City Park DRI

1st Round Narrative Response to Comments

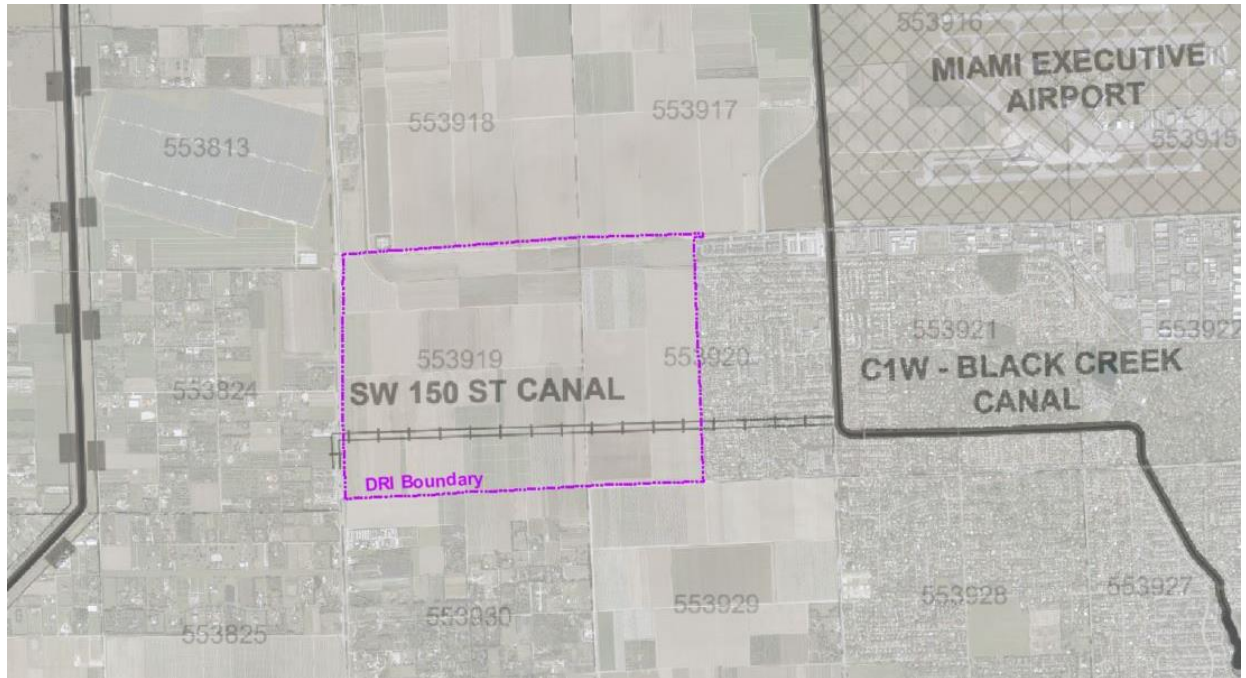
- e. The report states that exfiltration trenches will be designed for the 5-year, 1-hour storm event prior to discharge to the on-site wet-retention area, and runoff volumes are calculated with a 3.28-inch credit. This credit can only be granted if the exfiltration trenches are designed for the 5-year/1-day storm event. Revise the calculations accordingly.**

Response: The revised exfiltration trench calculations are included in the revised Conceptual Stormwater Management Master Plan to include the required trench for the 5-year/1-day storm event.

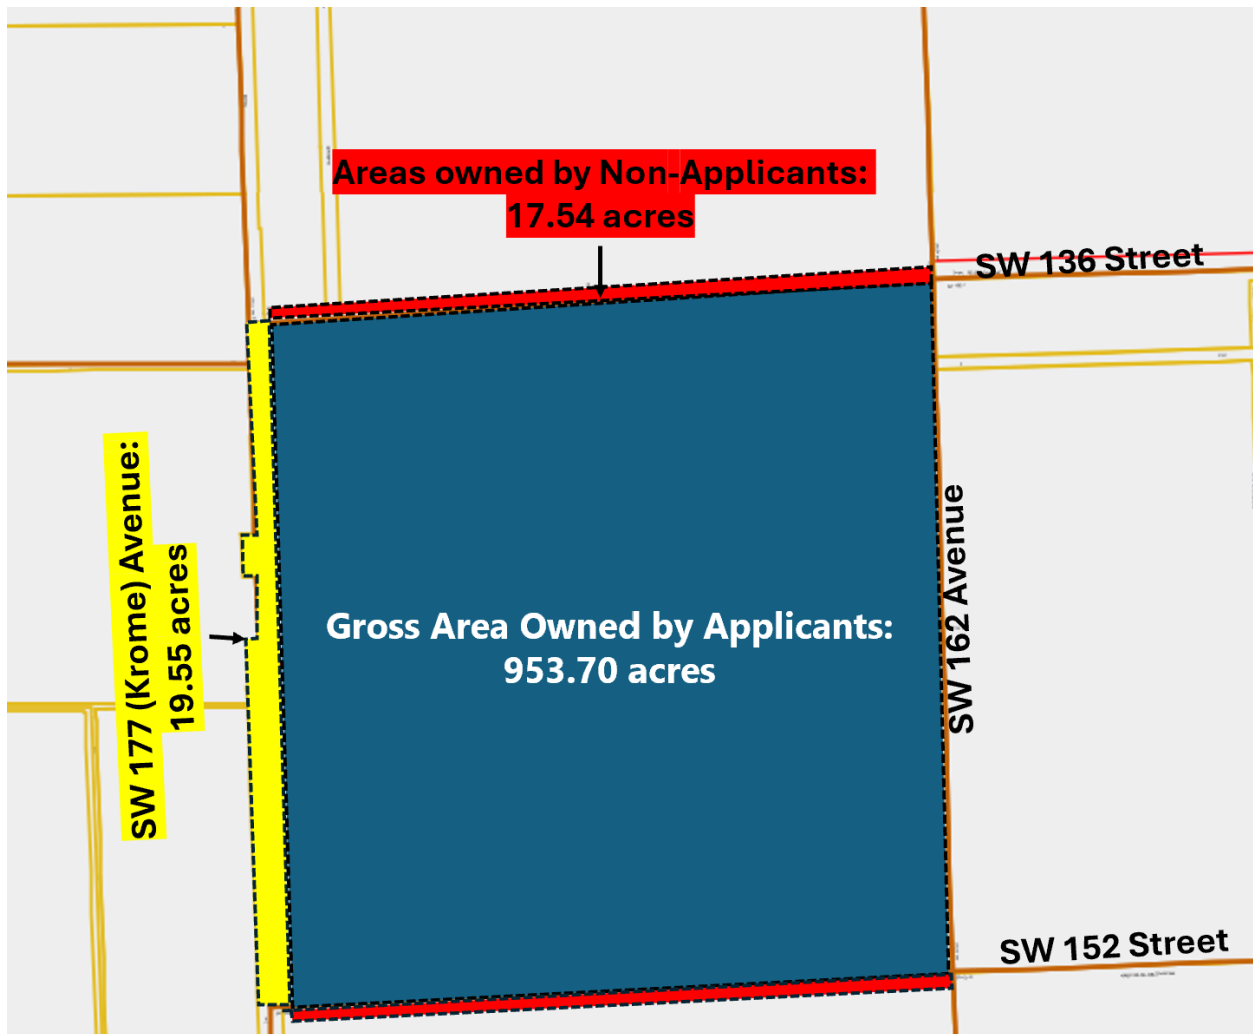
9. Page 10-1: The reported acreage is inconsistent between the DRI and the CDM applications. Please clarify and confirm the correct gross and net acreage of the application site to ensure consistency across all documents submitted to the County and to SFRPC.

Response: The application site consists of three different components that make up the “Total Application Area:” 1) the land owned by the Applicant; 2) lands abutting the south half of theoretical SW 152 Street and the north half of theoretical SW 136 Street that are zoned rights of way owned by non-applicants; and 3) lands dedicated and/or developed as Krome Avenue.

Total Gross Application Area	990.79 acres
Total Net Application Area	931.14 acres
Gross Area Owned by Applicants	953.70 gross acres (931.14 net acres)
Area Owned by Non-Applicants	17.54 acres (0 net acres – all zoned right of way)
Area of Krome Avenue between SW 136 ST and SW 152 Street	19.55 acres (0 net acres – all existing right of way)

The portions of the Total Application Area owned by Applicants, owned by non-applications, and consisting of Krome Avenue are illustrated below.
